Office Action Summary	Application No. 10/810,288	Applicant(s) TIMMERMANS ET AL.	
	Examiner JAMES L. SWIGER III	Art Unit 3733

DETAILED ACTION

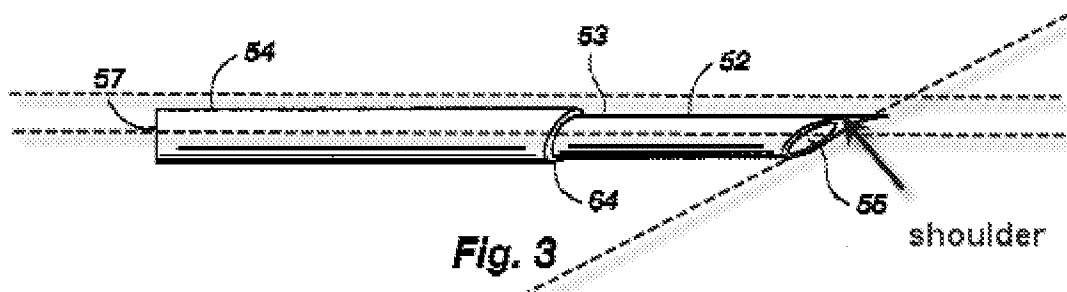
Applicant's arguments filed 4/28/2008 with respect to claims previously presented 1-31 have been considered but are not persuasive. Clark has a front annular face as noted above and further has a portion that is a shoulder. The shoulder is formed between said distally projecting single point and a remaining part of said front annular

face. In the drawing below, note the shoulder location is between the distal tip and the front annular face. It is also noted in regard to applicant's comments regarding the bevel, shoulder, and point, it is noted that the bevel is defined as something that does not form a right angle with any adjacent surfaces. The intersecting lines in the drawing below meet at the point. The lines meet slightly above the point in the drawing. In this regard, they create an angle that is not 90 degrees and form a point.
